Date: 4/22/2014
 Job Name: Warren BRF 013-4(32)
 Job Number: SDI #14046
 Regarding: Abutment Leveling Plates and Support Bolt submittal

REV	DESCRIPTION	DATE	DET	CKD
	LOCATION — VT ROUTE 100			
	BRIDGE — 166		43335-1107-1	16 OF 16
	PROJECT — BRF 013-4 (321)			
	P.O. NO. — 14046			
	DESIGNER — McFARLAND JOHNSON			
	CUSTOMER — S D IRELAND CONCRETE			
	SCALE: N.T.S.	DATE: 4/14		
	PROJECT NUMBER: 43335	PROJECT CODE: 1107		1

ANCHOR ROD DETAIL
(16) REQ'D @ ABUTMENT 1
(16) REQ'D @ ABUTMENT 2
(32) REQ'D TOTAL

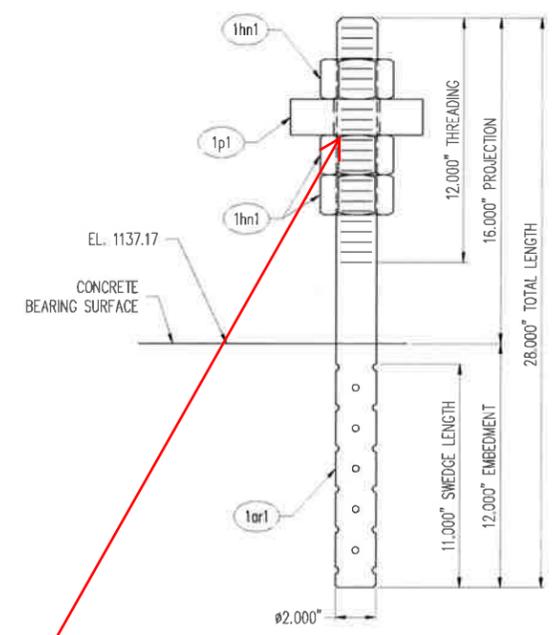
Plate Washer Required Grade 105

Plate Washer Required
